COA # 2011-COA-409 (IRV)	INDIANAPOLIS HISTORIC PRESERVATION COMMISSION STAFF REPORT	Hearing Date NOV. 2, 2011
41 N WHITTIER PLACE IRVINGTON		NEW CASE Warren Township Council District: 21 Benjamin Hunter
Applicant GROVER B. DAVIS, attorney for SHATAWN LOWHORN mailing address: 235 N. Delaware Indianapolis, IN 46204		
Owner: same		
VIOLATION CASE (WORK STARTED WITHOUT APPROVAL)		
IHPC COA: 2011-COA-409 (IRV) <ul style="list-style-type: none"> • Retain inappropriate wood siding on front gable installed without approval • Replace inappropriate rear steel door with wood door. • Replace inappropriate aluminum clad windows on north side and vinyl window at front porch with wood windows • Modify attached shed-like structure at rear of house constructed without approval. 		
STAFF RECOMMENDATION: Approval with stipulations if applicant agrees

COA #2011-COA-409(IRV):

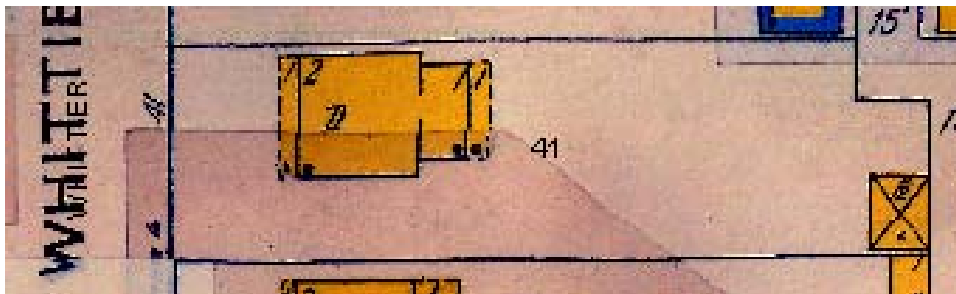
1. **Windows and Trim.** Staff believes the original windows could have been restored. However, now that they have been removed, the only appropriate remedy is to replace them with appropriately sized solid wood double-hung windows.

- a. **Three Windows on North Side.** Original wood double hung windows were replaced with aluminum clad windows. New wood double hung windows should be installed.

- b. **One Front Porch Window and Trim.** The porch window that was replaced was also modified in size and trim. This window should be replaced with a new wood window and wood trim to match the IHPC file photo of the original.

2. **Door.** The steel door on the rear of the house is inappropriate due to its material and design. This door should be replaced with a solid wood door of a design typical of the time period of the house.

3. **Rear Shed-like Structure.** The structure could be appropriate if finished properly. However, staff would need to see a drawing of how the structure would be completed. Photos seem to indicate that this structure was there before Ms. Lowhorn purchased the property, but she has since altered and modified it without a COA.

1. **Front Gable.** The applicant removed the original wood shingles and replaced them with wood lap siding. The lap siding should be removed and appropriate wood shingles to match the originals should be installed.
2. **One Window and Trim – South Side Stair Window.** The original wood double-hung window was removed and replaced with a vinyl double hung window. It should be replaced with an appropriately sized solid wood double-hung window.

- 1. Replacement of three aluminum windows installed without a COA on the first floor of the north side with new wood double-hung windows**
- 2. Replacement of one vinyl window installed without a COA on the 1st floor front elevation with a new wood window to match the size and trim of the original window (not the inappropriate, re-sized window.)**
- 3. Replacement of one vinyl window installed without a COA on the south side at the stair landing with a new wood double hung window and installation of trim to match the original.**
- 4. Replacement of the rear steel door installed without a COA with an appropriate wood door.**
- 5. Replacement of the front gable lap siding installed without a COA with wood shingles.**
- 6. Completion of attached rear shed-like structure constructed without a COA**

- 1. Final drawings showing how rear porch attached rear shed-like structure is to be designed and built shall be submitted to IHPC staff for final approval. Approved _____ Date _____**

- 2. New window and door selections must be approved by IHPC staff prior to purchase and installation. Approved _____ Date _____**
- 3. New shingles at front gable shall be real wood and match the shingles that were originally found on the gable as found in the photo documentation in the IHPC building file. Final shingle selection must be approved by IHPC staff prior to installation. Approved _____ Date _____**
